**RAI 03.07.01-27, Supplement 1, Revision 1**

**Follow-up Question to RAI 03.07.01-19 (STP-NRC-100093)**

**REVISED SUPPLEMENTAL RESPONSE:**

**RAI 03.07.01-27, Supplement 2, Revision 1**

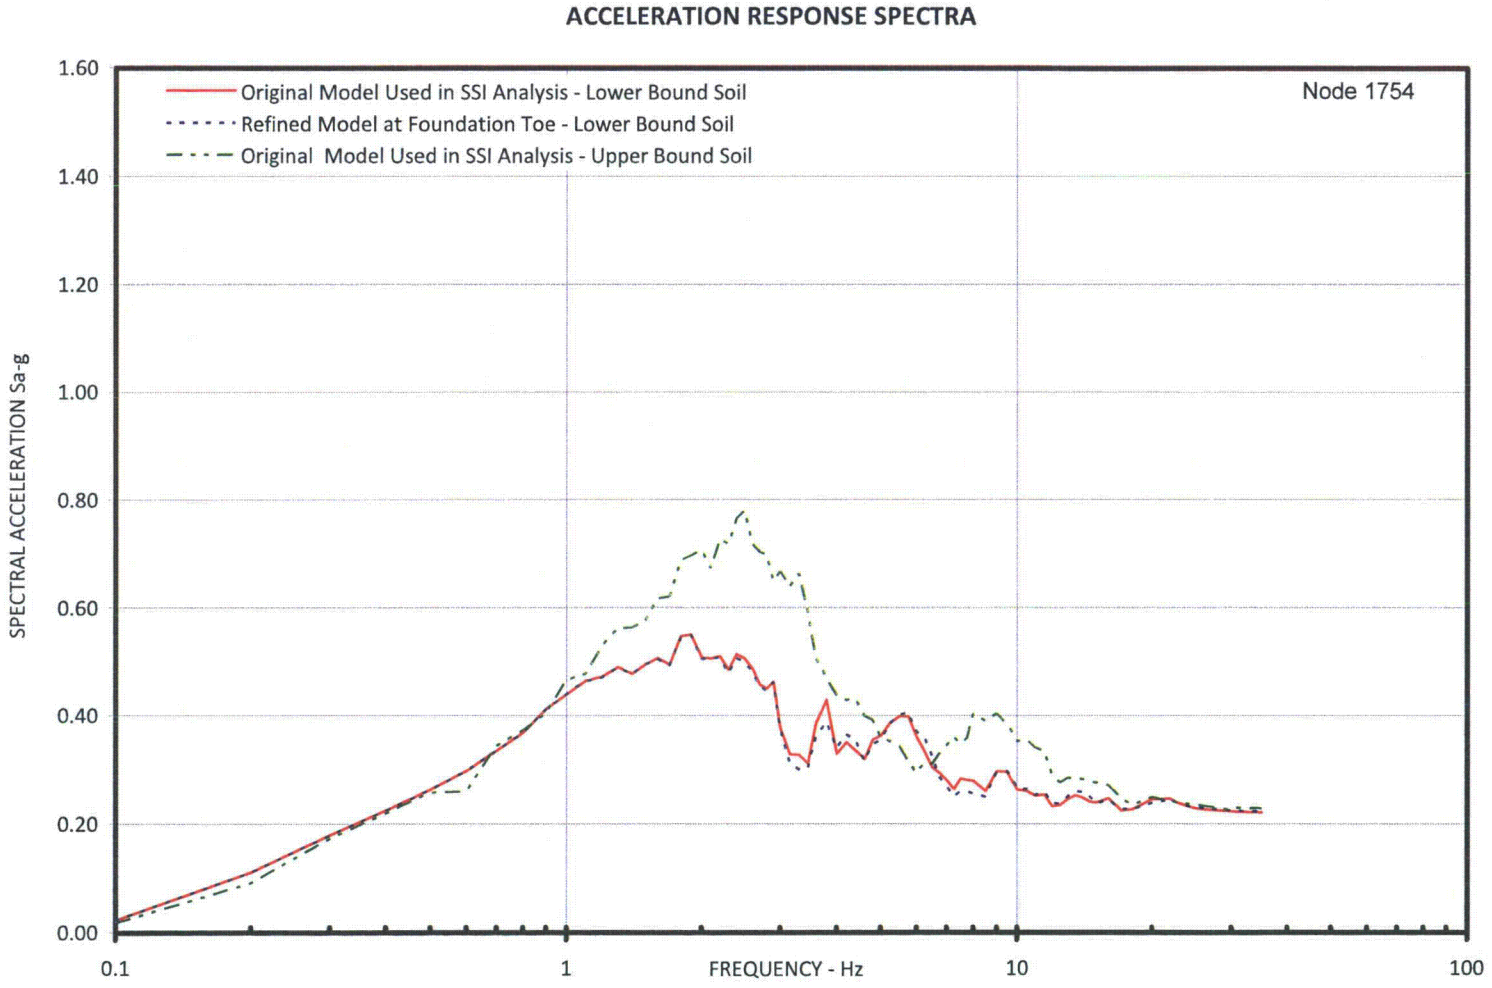
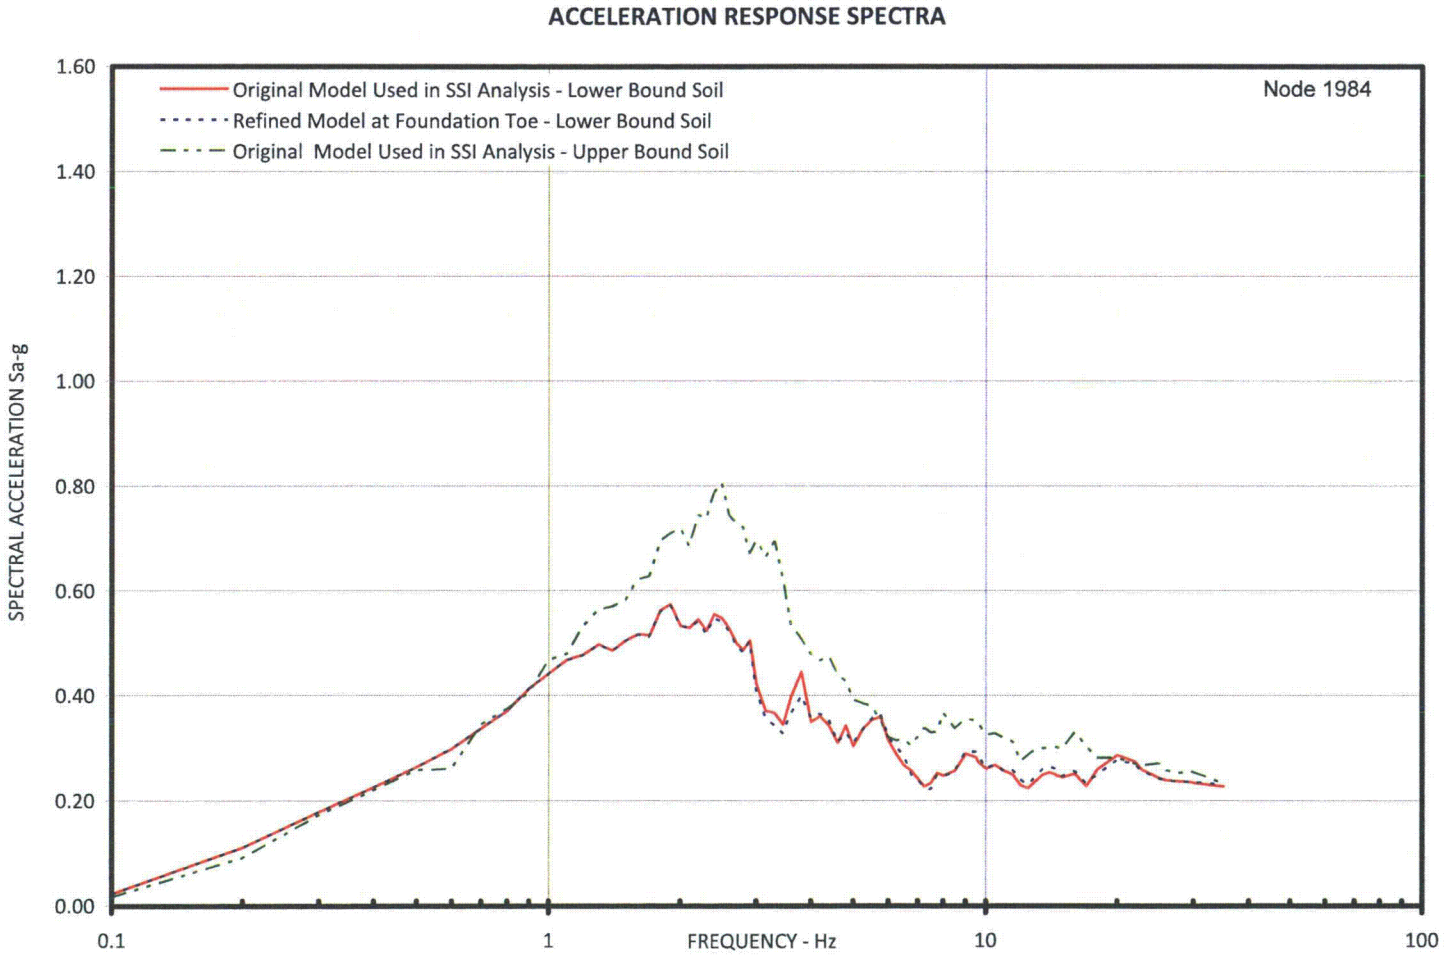
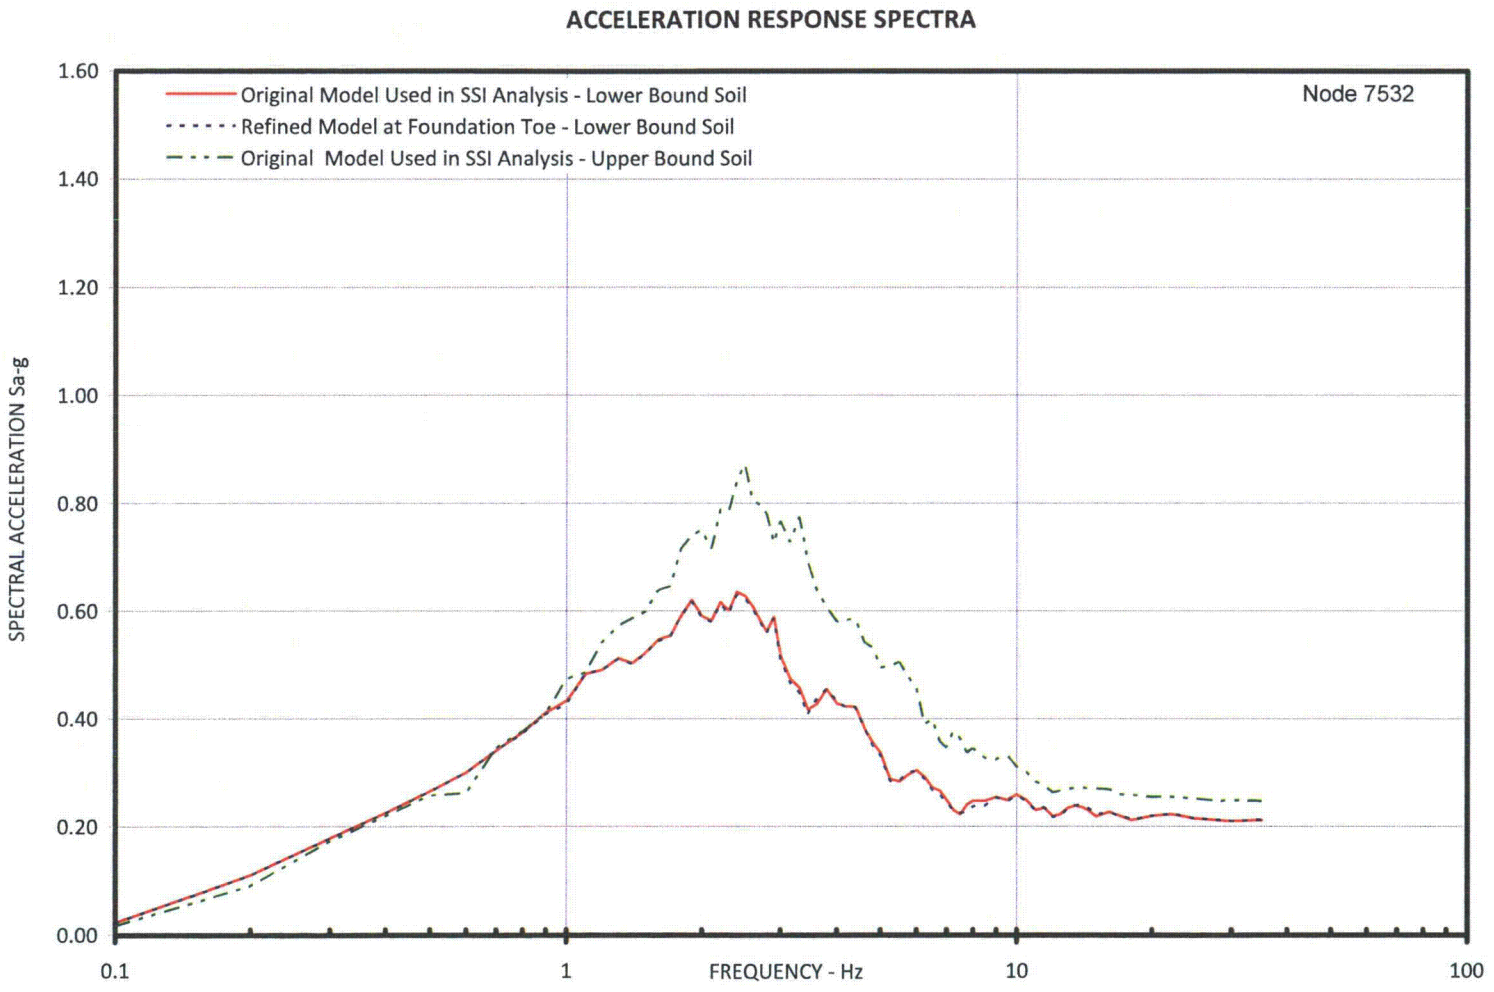
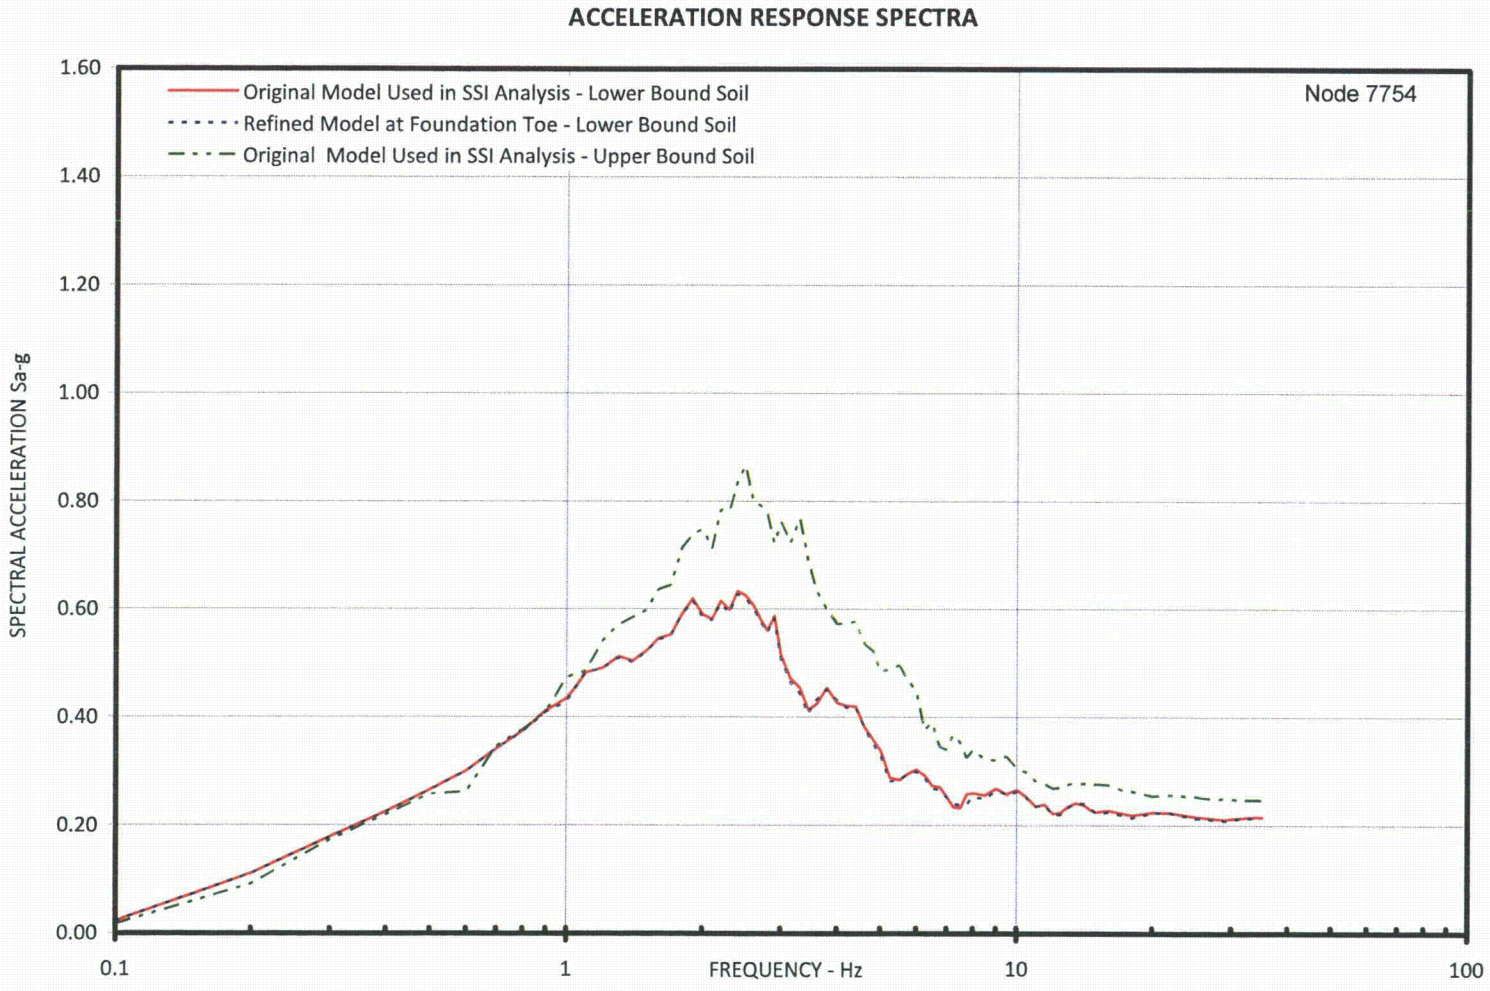
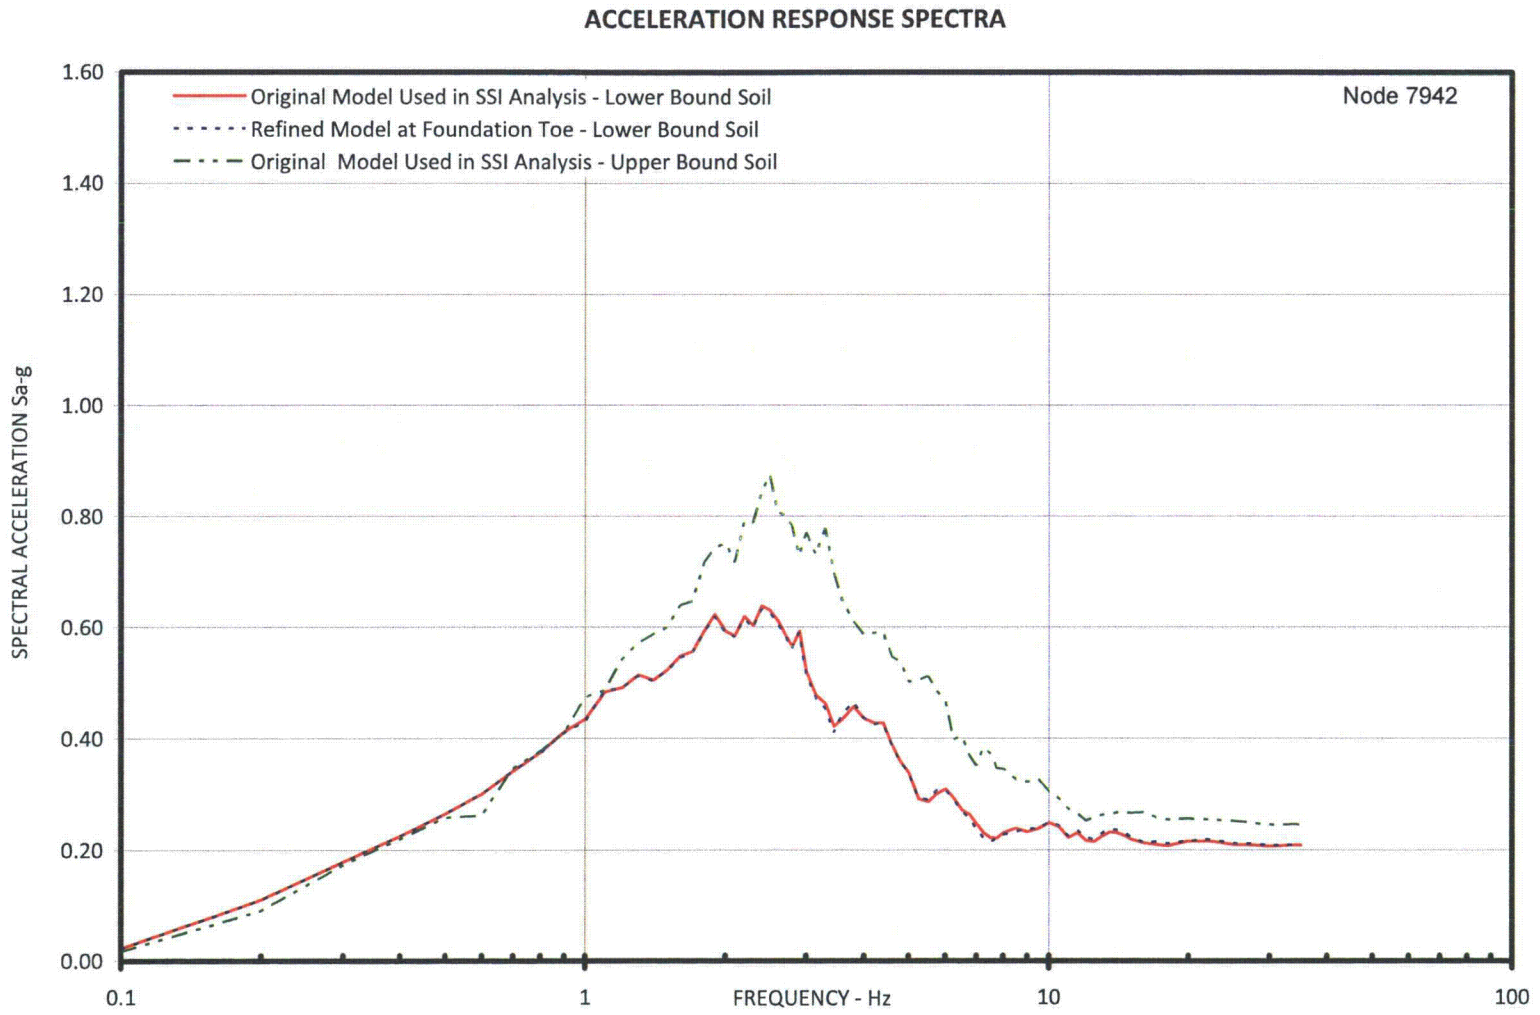
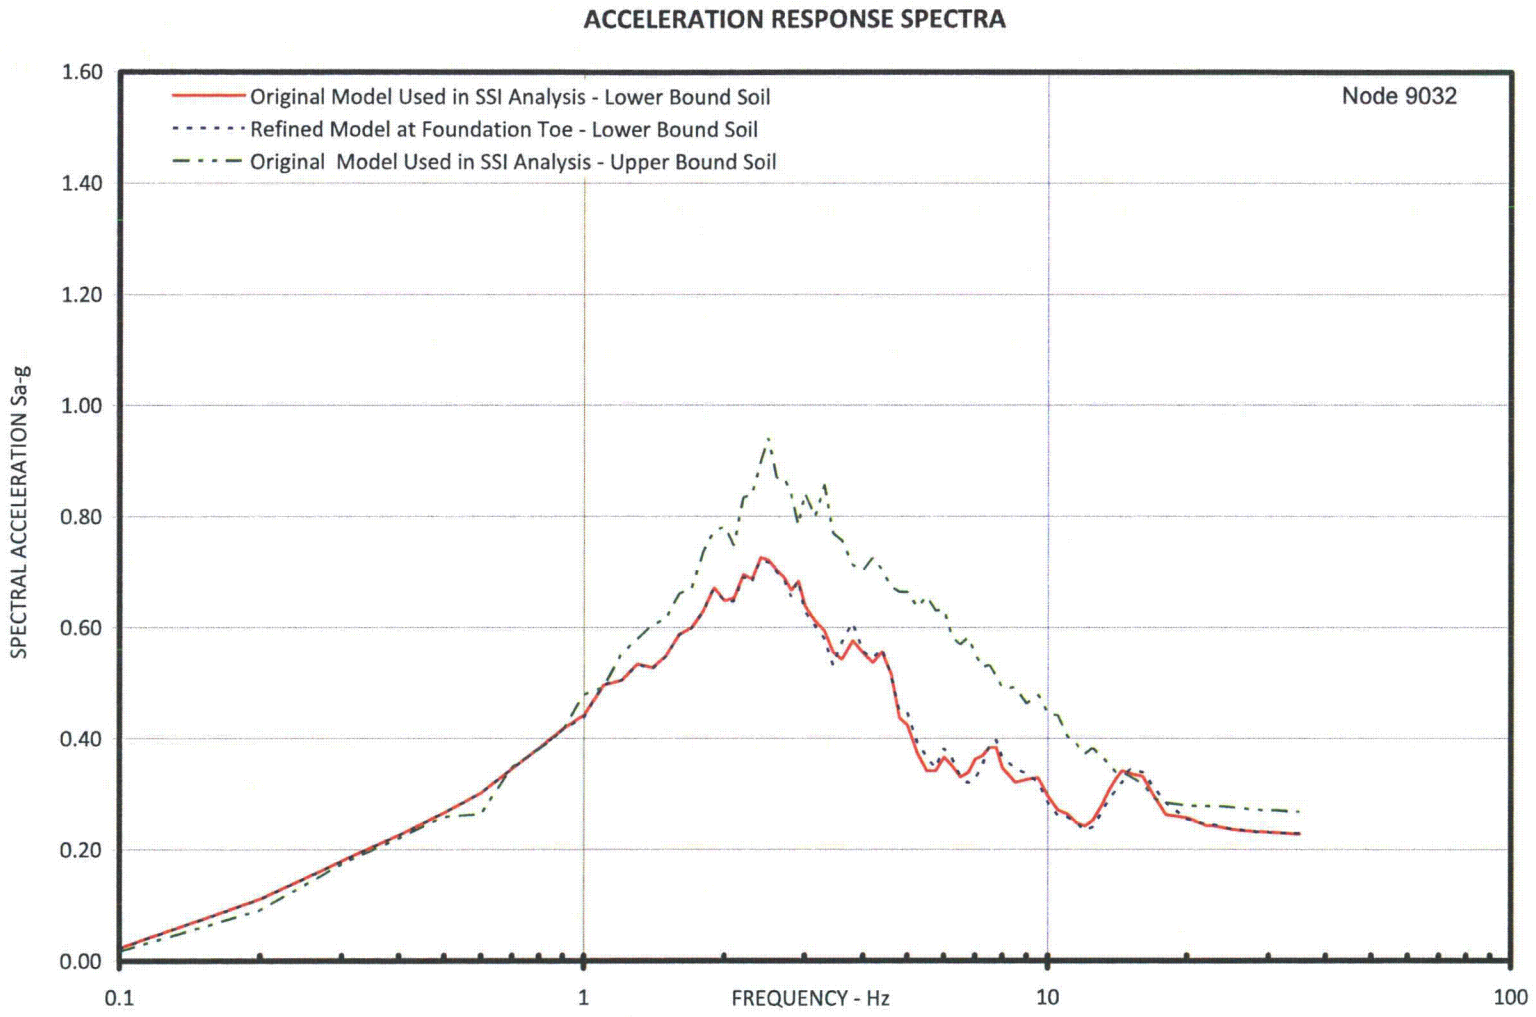
1. 10CFR50, Appendix S requires that evaluation for SSE must take into account soil-structure interaction (SSI) effects and the expected duration of vibratory motion. In the response to the first paragraph of RAI 03.07.01-19, the applicant has presented its approach for developing the input motion for the SSI analysis and design of the DGFOSV that takes into account the impact of the nearby heavy RB and RSW Pump House structures. The applicant also stated that *"Conservatively, a 3-dimensional SAP2000 response spectrum analysis was used to obtain the safe-shutdown earthquake (SSE) design forces due to structure inertia. The seismic induced dynamic soil pressure on DGFOSV walls were computed using the method of ASCE 4-98, Subsection 3.5.3.2"* The response, however, does not provide details as to how the SSI analysis of the DGFOSV are performed and how the input motion developed are subsequently specified in the SSI analysis of DGFOSV to develop the structural response and in-structure response spectra for any equipment and subsystems within DGFOSV. From the response it appears that the applicant has not included explicitly DGFOSV structural model in the SASSI model of the RB and RSW Pump House structures to properly evaluate the SSSI effect on the DGFOSV. In order for the staff to determine if the evaluation of DGFOSV for SSE has appropriately accounted SSI effects, the applicant is requested to provide in the FSAR the following information:

To evaluate the effect of 20 Hz passing frequency for LB in-situ case, the foundation toe was divided into two elements, thus increasing the passing frequency to 40 Hz. This refined model with LB in-situ soil properties was analyzed and 5% damped spectra from this model were compared with the spectra from the original model with passing frequency of 20 Hz. The spectra comparison plots are shown in Figures 03.07.01-27.1 through 03.07.01-27.24. The comparison shows that:

- In the X direction, there is insignificant difference between the response spectra from the two models
- In the Y direction, the response spectra from the two models matched well except at frequency of about 3.8 Hz where the refined model produced higher spectra.

However, spectra from both the models are enveloped by the spectra for UB in-situ soil case

- In the vertical direction, the spectra from the two models matched well (insignificant difference)

Based on the above evaluation it is concluded that the horizontal direction passing frequencies are acceptable.
